**AGENDA
FARRAGUT MUNICIPAL PLANNING COMMISSION**

**May 18, 2017
7:00 p.m. Farragut Town Hall**

SUBJECT: Discussion and public hearing on a site plan for the NHC Memory Care Facility at 120 Cavette Hill Lane, 15.504 Acres, Zoned C-1 (National Healthcare Corporation, Applicant)

**SUBJECT: STAFF COMMENTS ON THE SITE PLAN FOR THE NHC
MEMORY CARE FACILITY AT 120 CAVETTE HILL LANE**

EXTERIOR ELEVATIONS AND SITE PLAN

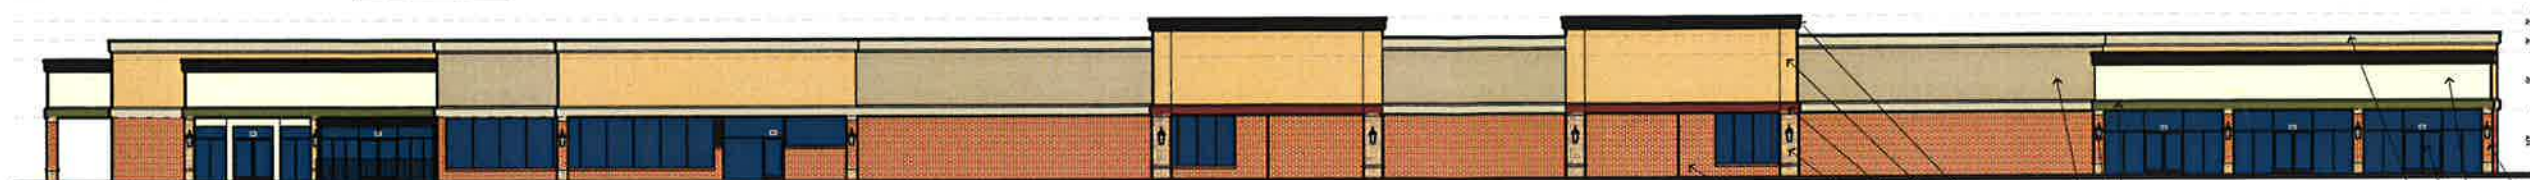
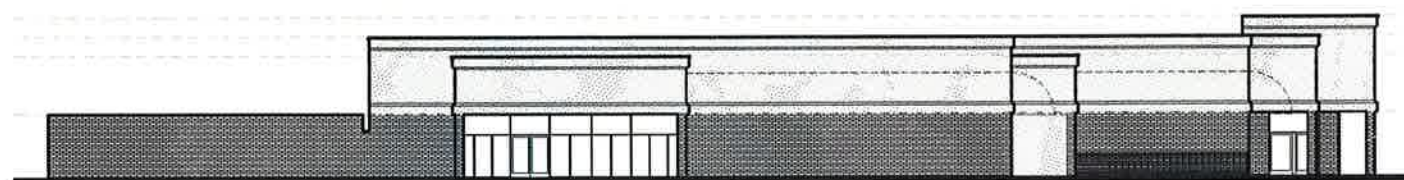
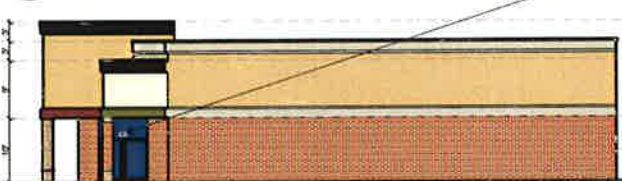
Included in your packet is a copy of the site plan which includes a before and after of the building façade. The lighting proposed at this time would be identical to the lighting that was used on the original re-face. Signage will be transitioned to a consistent and more town center style when individual signs are replaced. The owner is hoping to work with the tenants at this time so that the signage could be replaced while the re-face is underway.

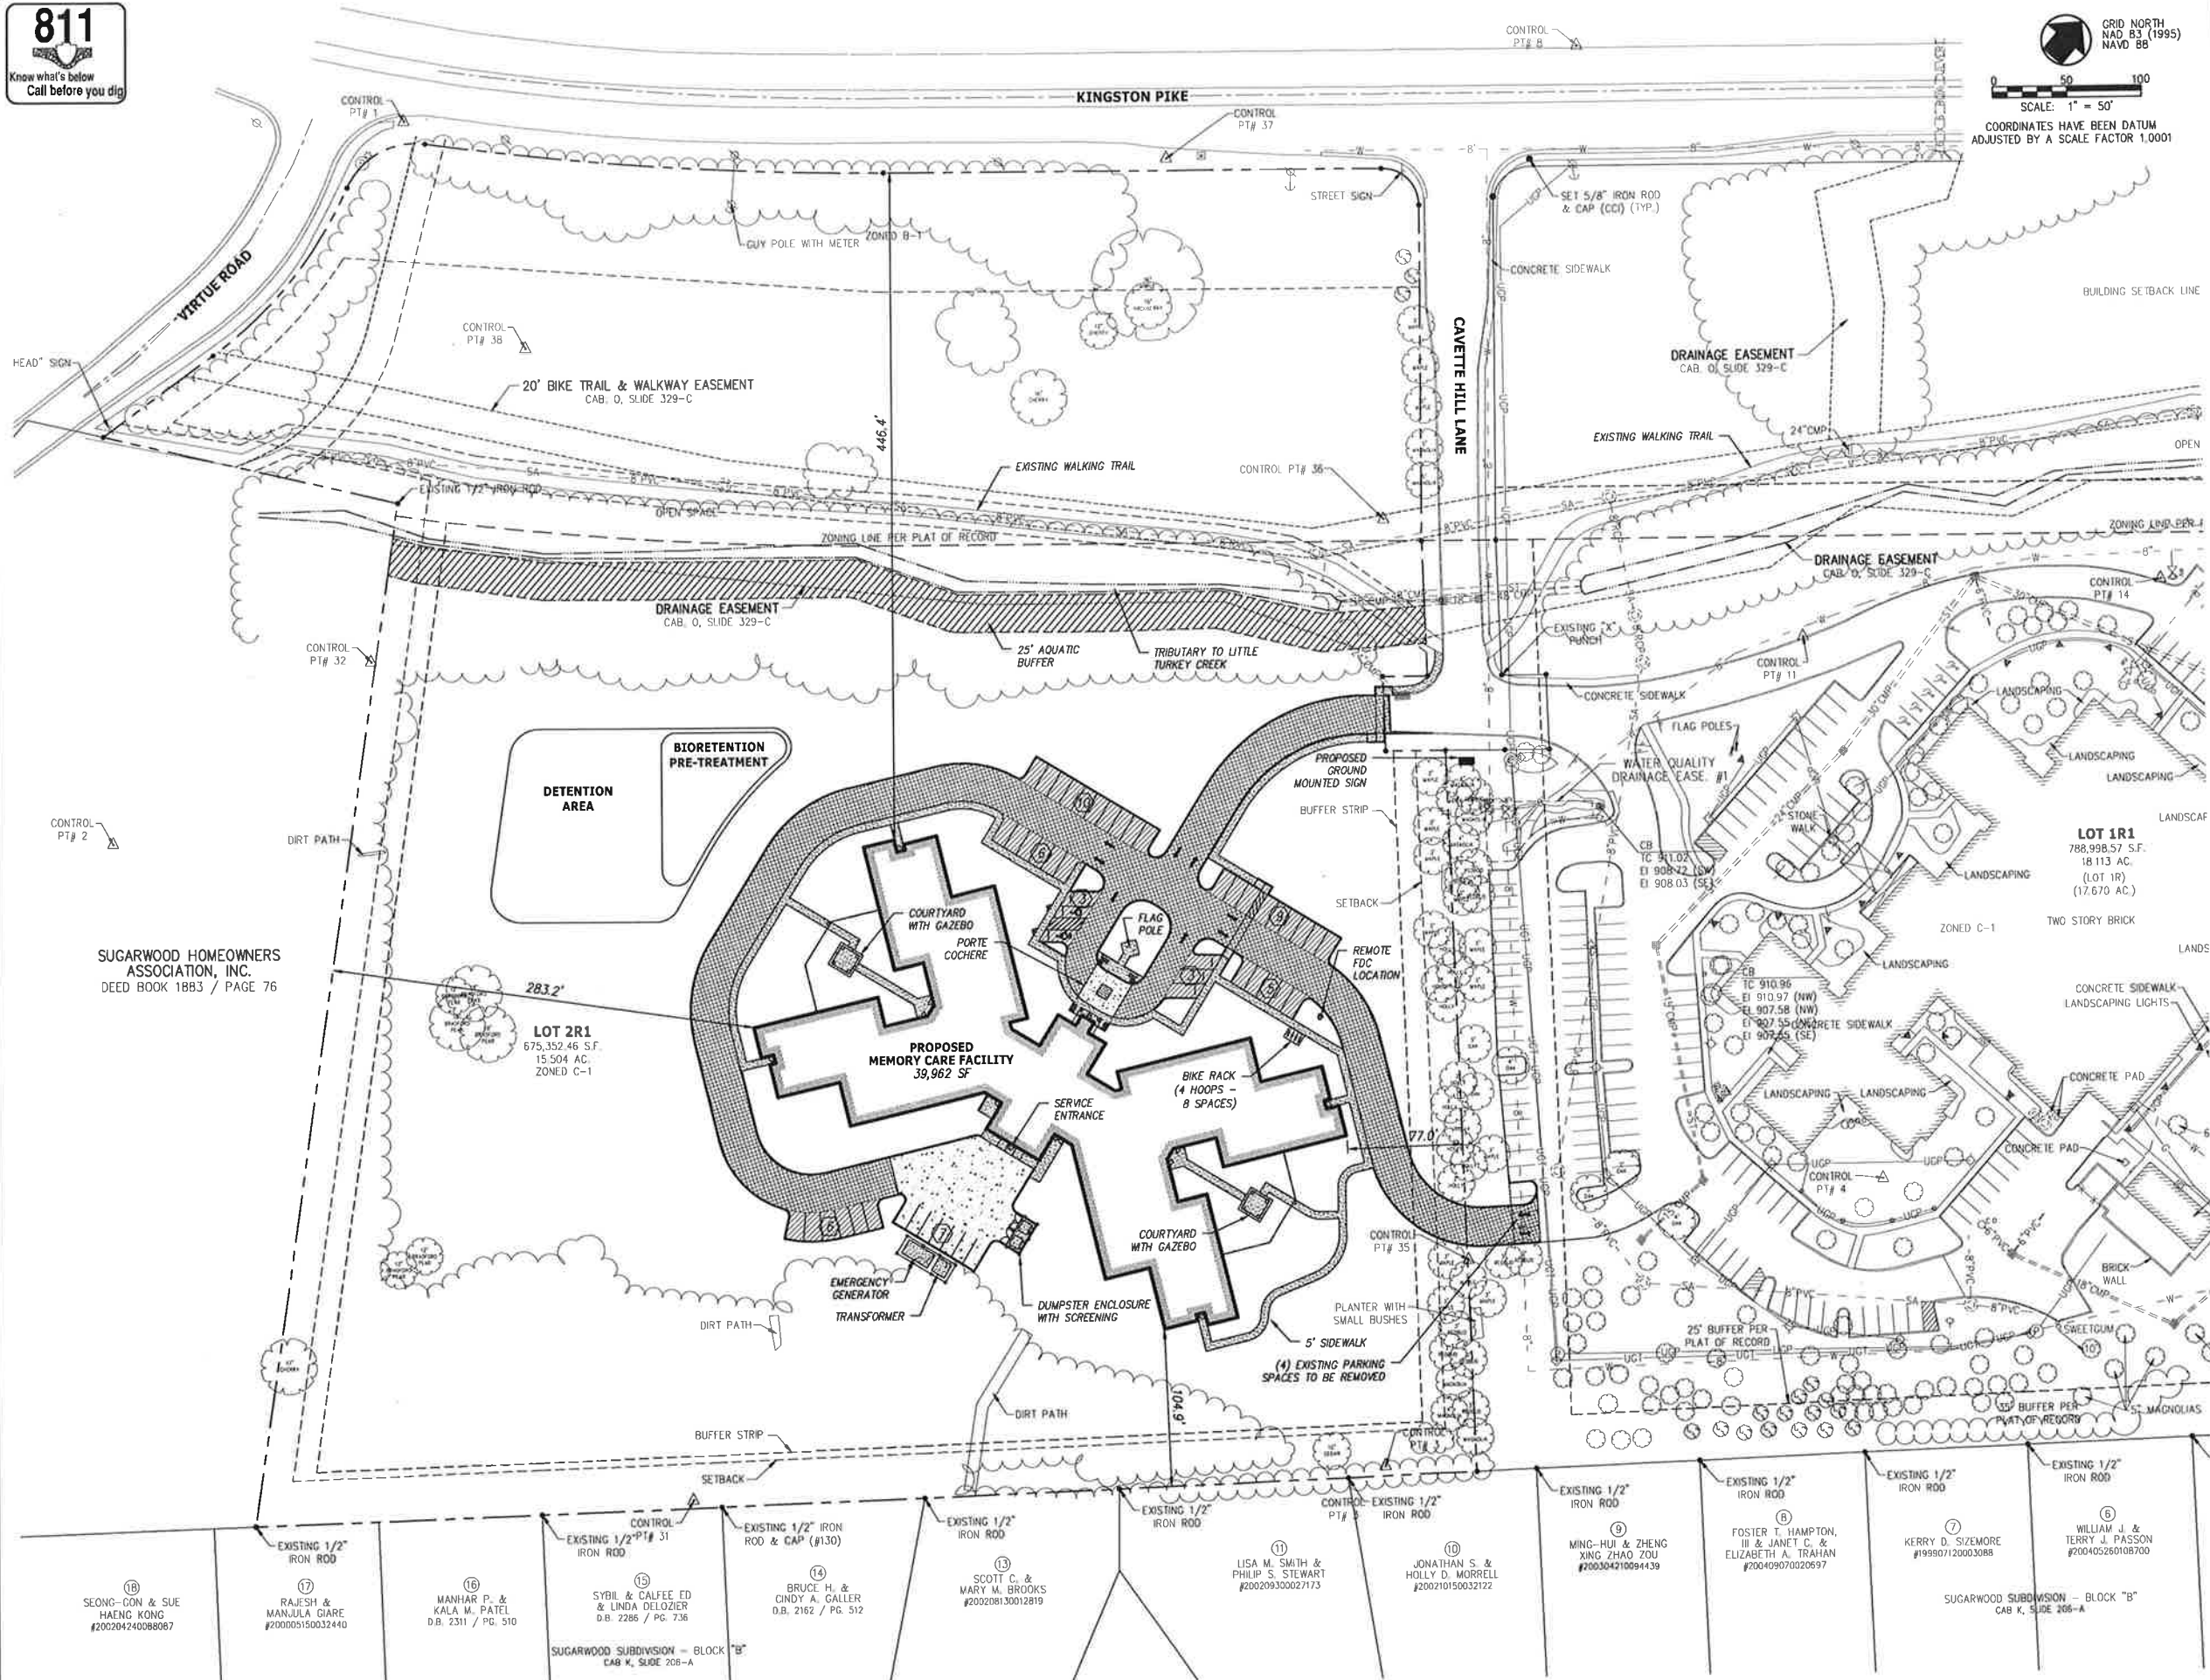
- 5) Please provide the location of the Fire Department Connection for the fire sprinkler system;

Response: Remote FDC location has been added to the Overall Site Layout (C1.01), Enlarged Site Layout (C1.02 and C1.03), and the Water Line Plan (C5.01).

1 L1.0 TREE PRESERVATION / REMOVAL PLAN
SCALE: 1"=50'-0"

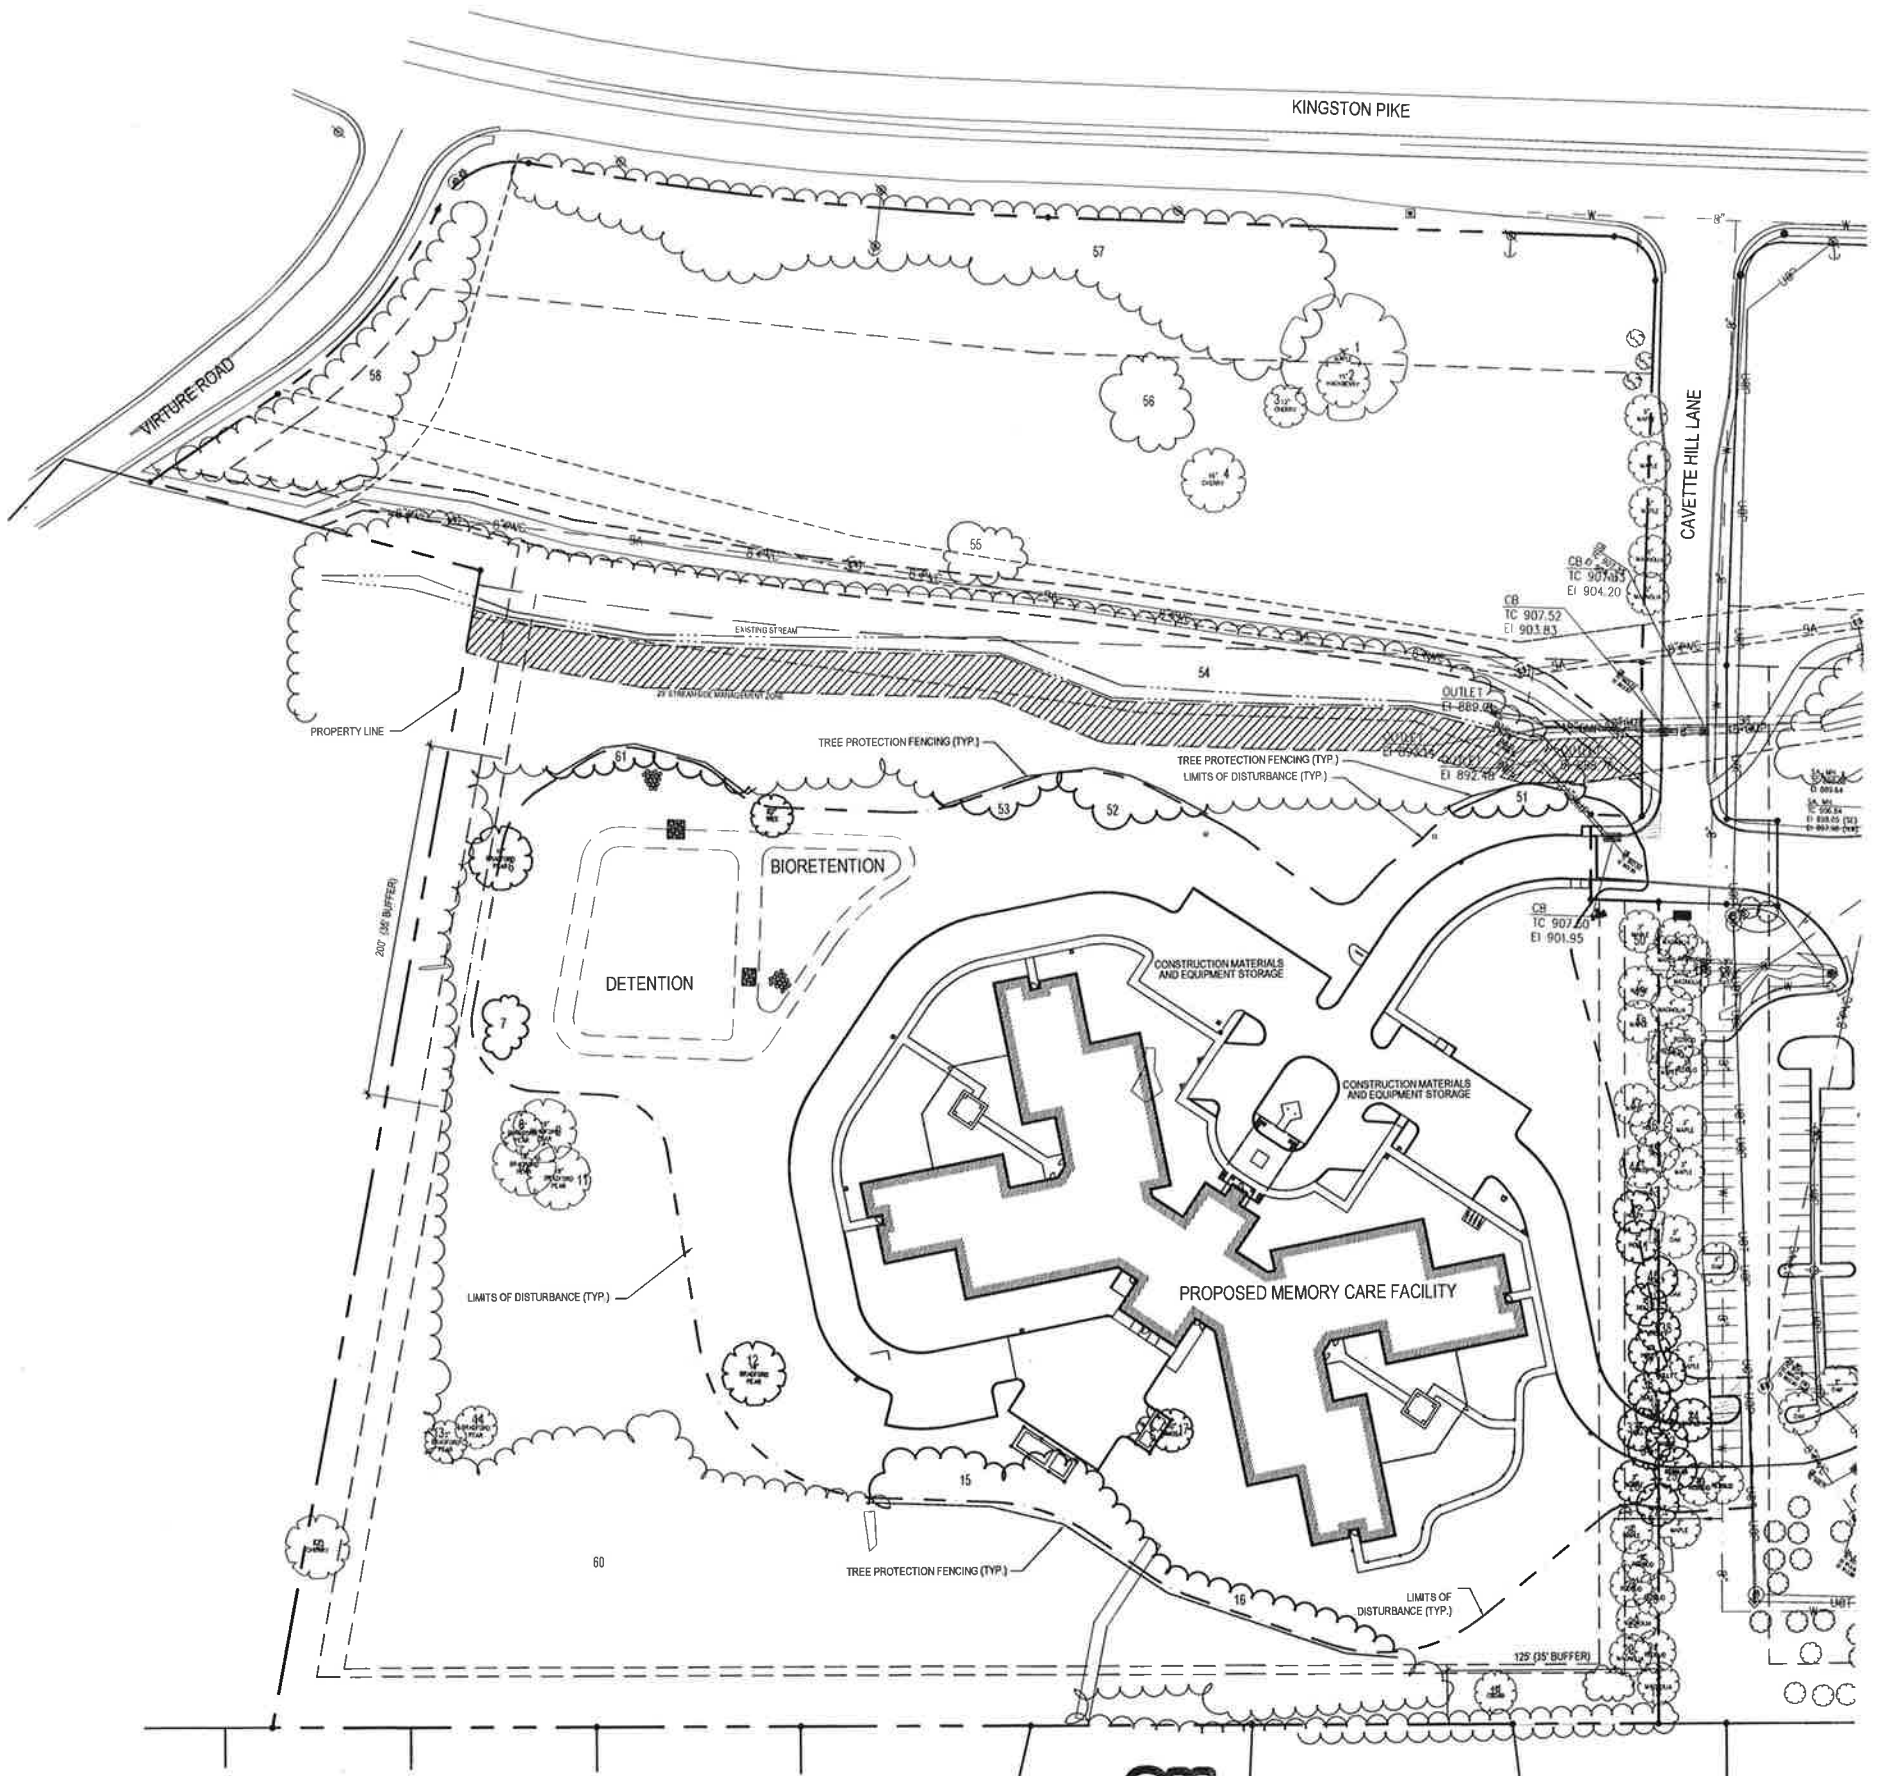
24) On the tree preservation plan please show in the table the mature hardwood stand (#60) as being saved;

Response: Tree preservation plan has been revised accordingly.
